Item #1:
Report Of June 16, 2014 Architectural Commission Meeting

TO: Village President and Village Board
FROM: James M. Hogue, Village Planner
DATE: June 17, 2014
RE: Board & Commissions Report for 6/24/14

2) **Consideration of a request for an amendment to the previously approved Special Use Permit and Planned Unit Development approval known as the Fairfield Village Planned Unit Development and with the R-2 PUD District to provide for a senior living center with Memory Care and Assisted Living Facilities and specifically the signage, landscaping, lighting, site plan/plat and building elevations proposed for the property at 1190 Old McHenry Road, submitted by Harbor Retirement Associates**

MILL POND SHOPS

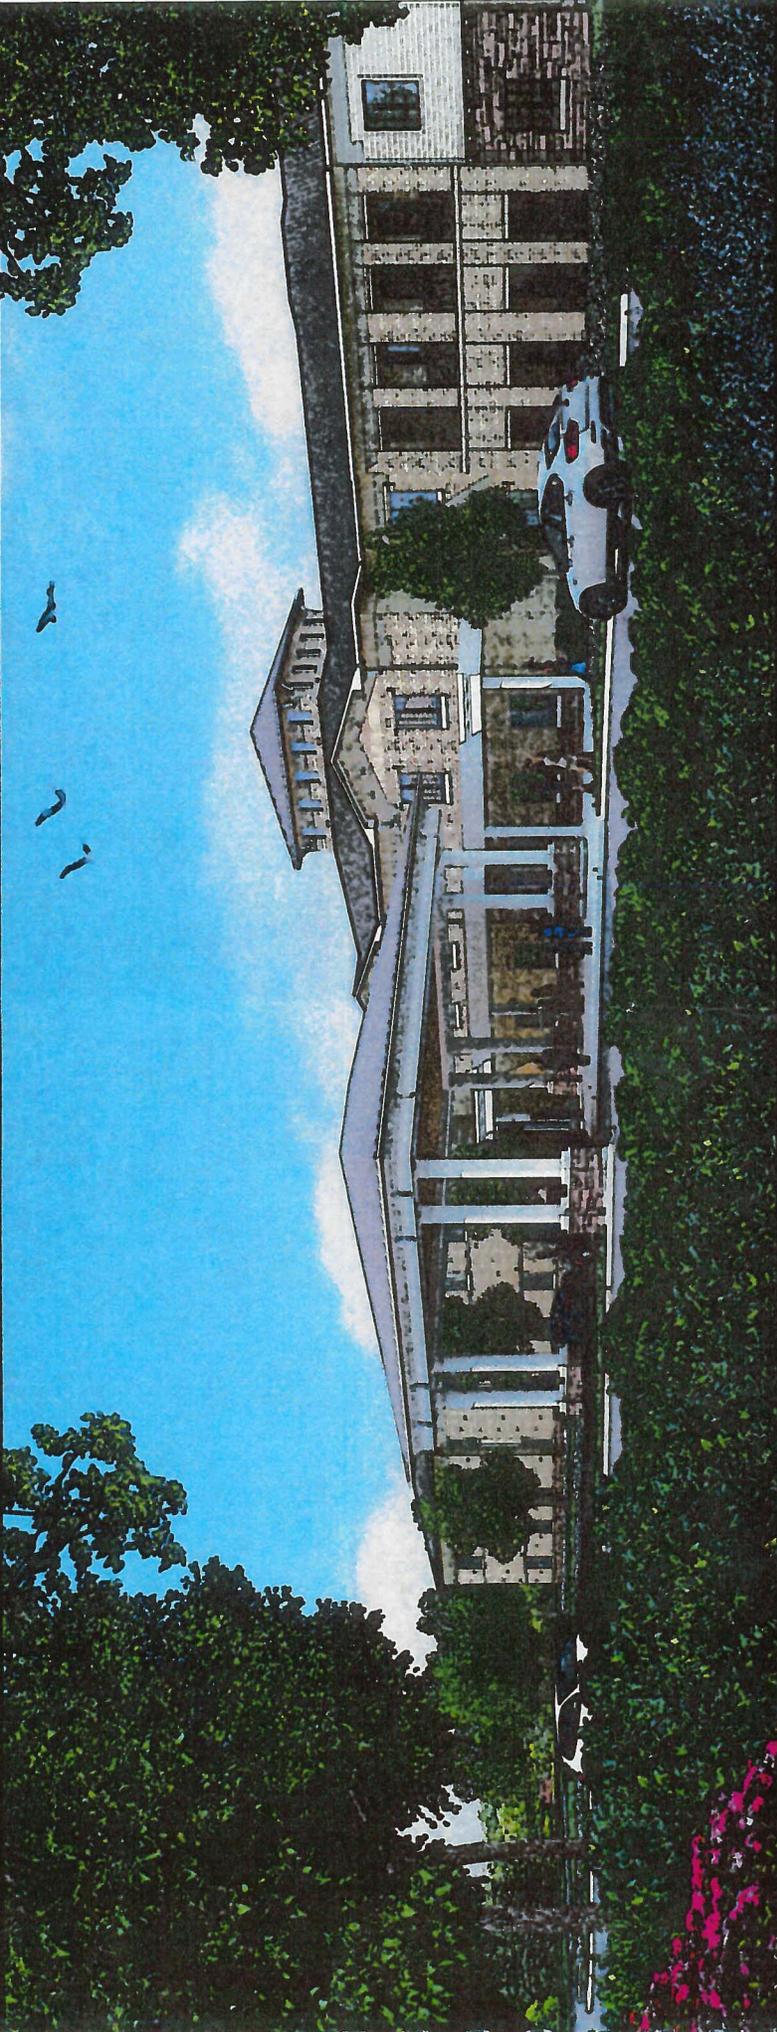
The AC had a concern with the placement of the sign and suggested the sign be lowered and the copy “Mill Pond” & “Shops” be placed closer together. A concern was also raised about the fastening of the letters to the building and permanence of that attachment.

The petitioner was amenable to the suggestions of the AC and noted the lettering would be securely fastened to the building.

Commissioner Calas made a motion, seconded by Commissioner Styer, to recommend approval of the signage as submitted subject to the spacing of the lettering being “tightened up” the lowering the signage on the wall and the signage being securely fastened to the building. On a voice vote; all aye.

3 EAST ELEVATION

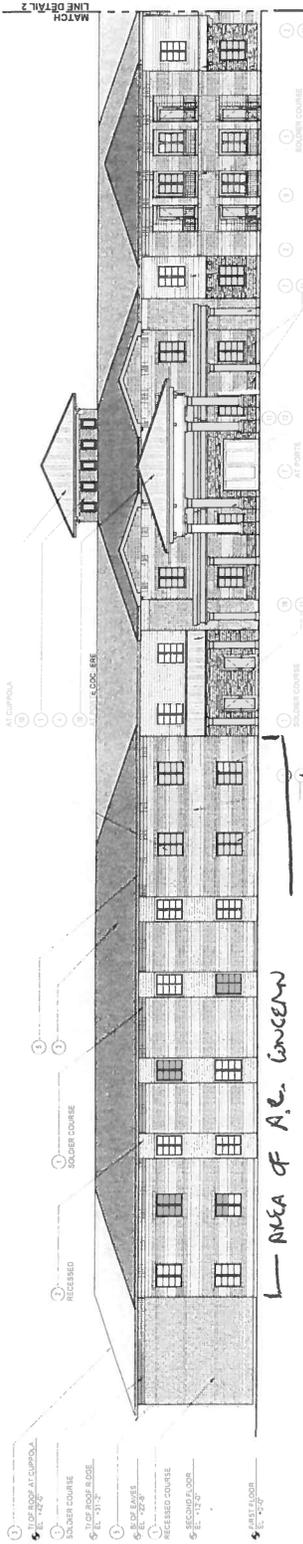
Commissioner Closson raised a concern with east elevation of the structure and large expanse of brick and windows from the “at porte cochere” to the south end of the building and the look of this from Rt. 83. His concern stemmed from the “gateway” nature of this property into the Village. He suggested the petitioner considered modifications to the roof lines to relieve the monotony.

AREA OF A.C. CONCERN

Petitioners were amenable to this suggestion and would work to incorporate this suggestion into the final elevations of the structure.

A motion was made by Commissioner Calas, seconded by Commissioner Closson; to accept the preliminary elevations for the proposed structure as submitted with the condition that the roof lines be altered on the east elevation to minimize the monotony of the structure. On a voice vote; all aye.

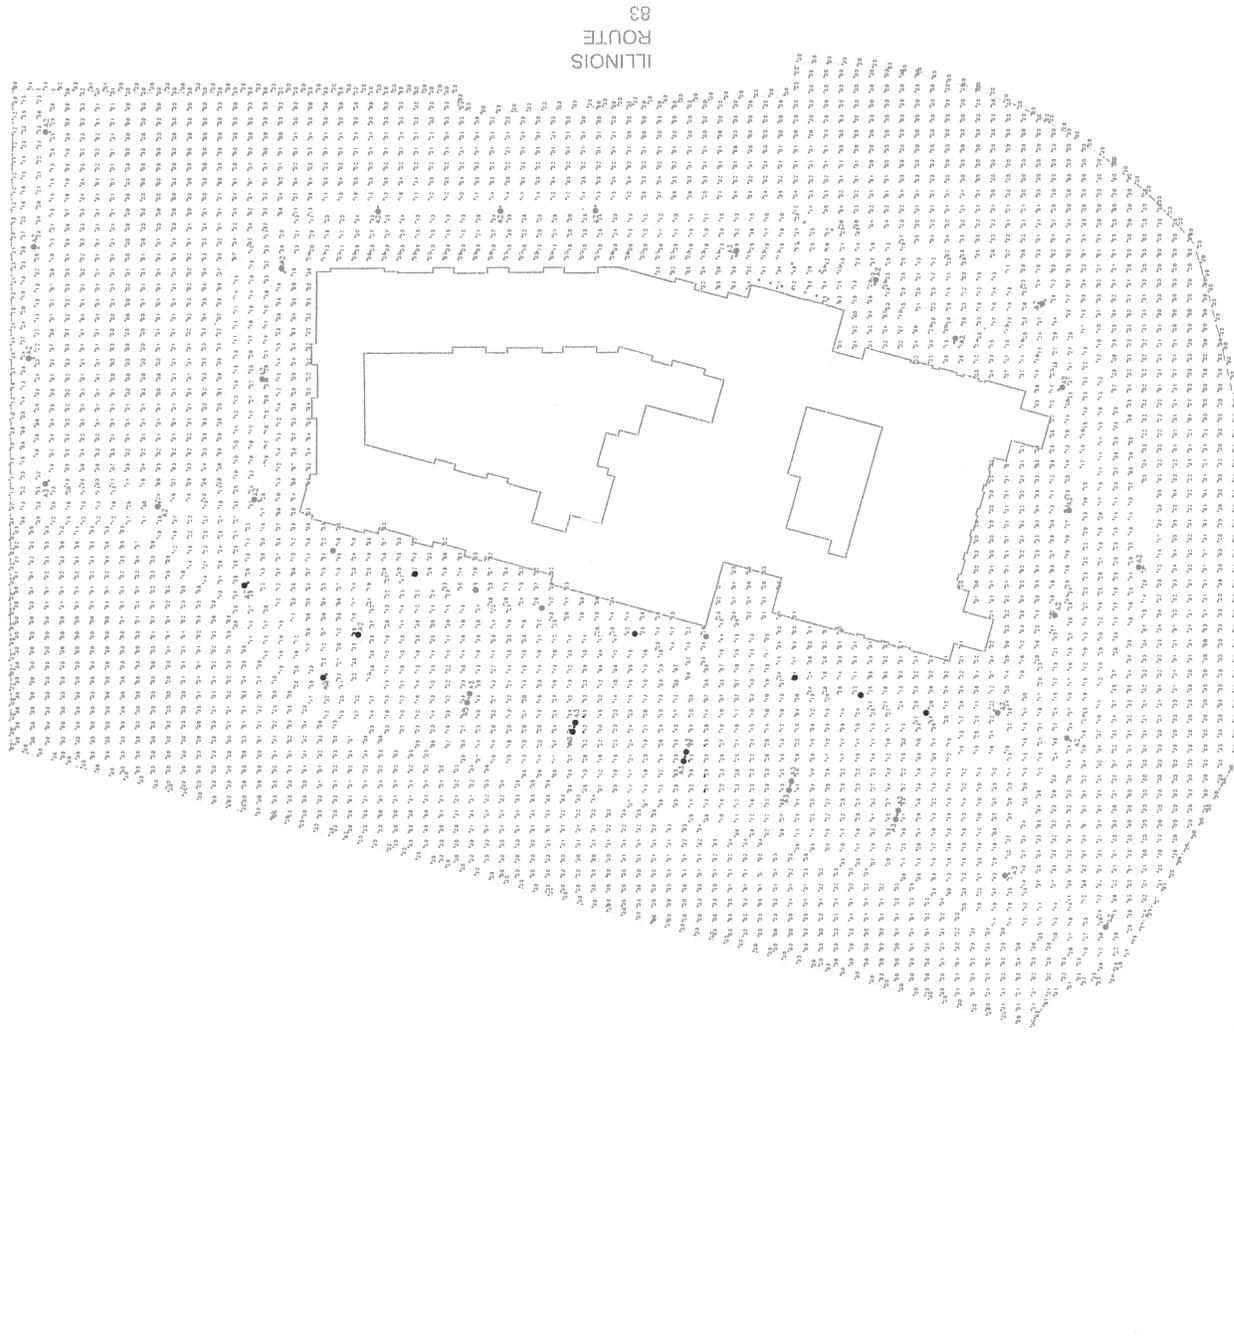
The AC reviewed the lighting plans as submitted, particularly the photometric plan and noted no light “escaped” from the property, particularly along the west lot line abutting residential uses. The AC found the requested lighting to be in conformance with the lighting standards for the Village.

A motion was made by Commissioner Styer, seconded by Commissioner Closson, to recommend approval of the proposed lighting as submitted including fixture style, illumination source (LED) and fixture height (18 feet). On a voice vote; all aye.
